# Validation Report

Changes to Project Design of a  
Registered Project Activity and Changes  
to the Registered Monitoring Plan

Solar Farm at Nakhonsawan,  
Thailand

Report No. 01 997 9105076935  
Version 03, 2014-03-31

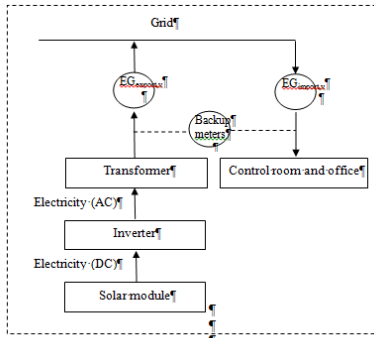
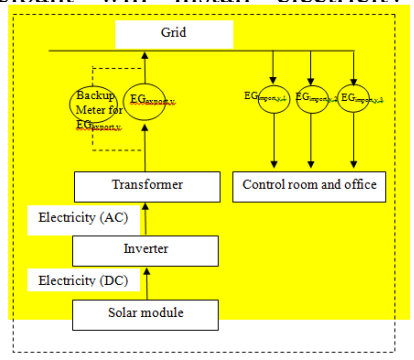
However, there are the changes of the registered monitoring plan by (1) installing 3 imported meters (changes from 1 meter to 3 meters) for monitoring the electricity consumption by control room and offices and (2) there is no back-up meter for imported electricity monitoring. By document review /3/, /8/, /34/ and on-site physical inspection, the validation team confirms that the changes still comply with application of applied methodology, ACM0002, version 12.3.0 and justification details will be shown in section 3.2 on this report.

<b>Section B.7.3</b> The project participant will install electricity meter(s) as follows:  <p>Figure 6: Monitoring Meter Flow Diagram</p>		<b>Section B.7.3</b> The project participant will install electricity meter(s) as follows:  <p>Figure 6: Monitoring Meter Flow Diagram</p>	
		<p>By document review /3/, /34/, and on-site physical inspection, the validation team confirms that there are permanent changes from the registered PDD /2/ as per requirements in paragraph 262 – 266 of VVS, version 05.0. and comply with requirements in applied methodology, ACM0002, version 12.3.0.</p>

By document review /2/, /3/, /8/, /34/ and on-site physical inspection, the changes of monitoring plan are to (1) install 3 imported meters (changes from 1 meter to 3 meters) for monitoring the electricity consumption by control room and offices and (2) there is no back-up meter for imported electricity monitoring. However, the electricity meter accuracy for all 3 imported meter has no change (i.e. at least 2% accuracy) from the registered PDD /2/. Therefore, the validation team confirms that the changes on monitoring plan have no impact on the level of accuracy of the monitoring plan and do not reduce the level of accuracy of the monitoring compared with the requirements contained in the registered monitoring plan, in line with requirements in the paragraph 263 of VVS, version 05.0 /5/.

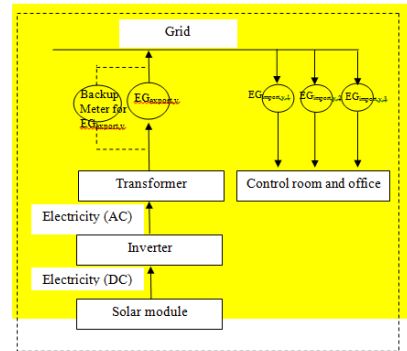
No.	CAR/CL	Observation (CAR/CL)	Summary of project owner response	Validation team conclusion																			
1	x	CAR1 Installation capacity and specification of PV module and inverter is not same with the revised PDD.	<p>The proposed 126.126 MWp solar photovoltaic power plant project tentatively will comprise of the following units:</p> <ul style="list-style-type: none"> <li>• 508,794 units of photovoltaic modules</li> <li>• 180 units of inverters</li> <li>• 101 units of transformer</li> </ul> <p>The technical specification of the solar module to be used in the project activity is given in the following table:</p>
